NorthernGrid

EPSC: Draft Regional
Transmission Plan
Comments
August 20, 2021

Violations

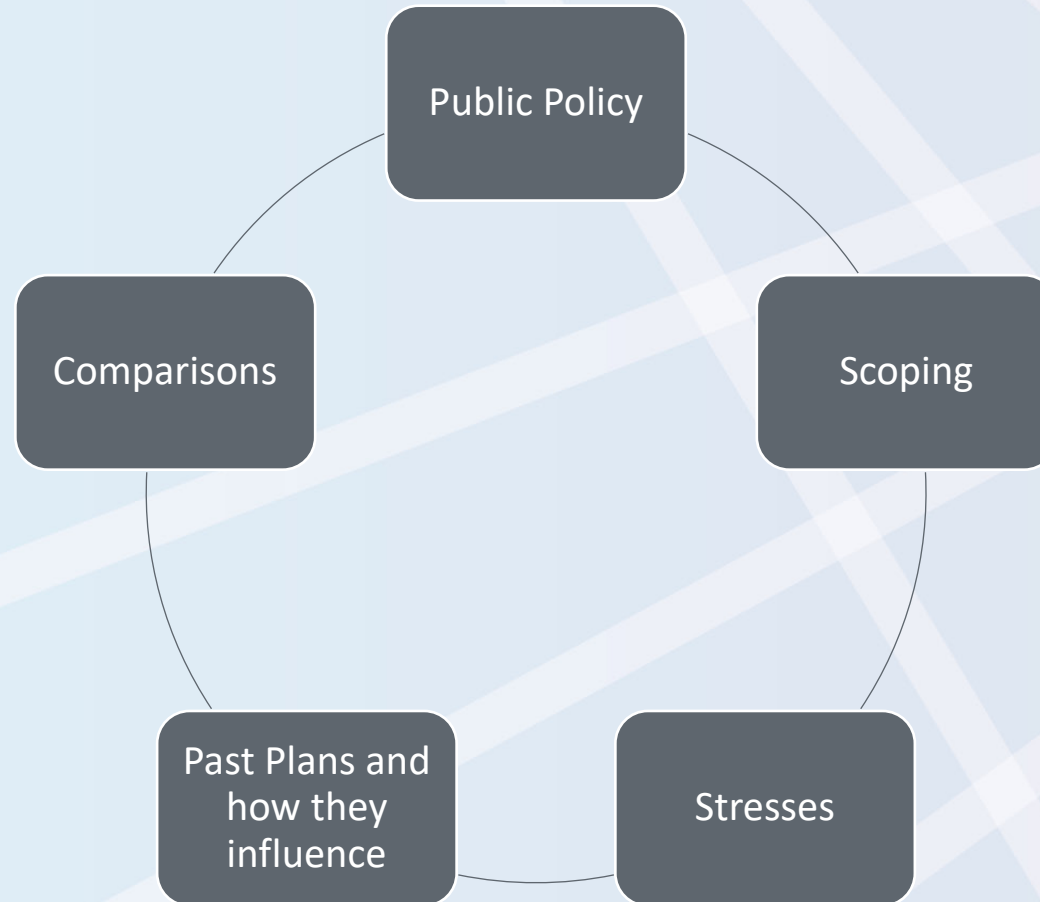
- What are they and why do they matter

More explanation needed

- Why RC03
- What other voltage considerations
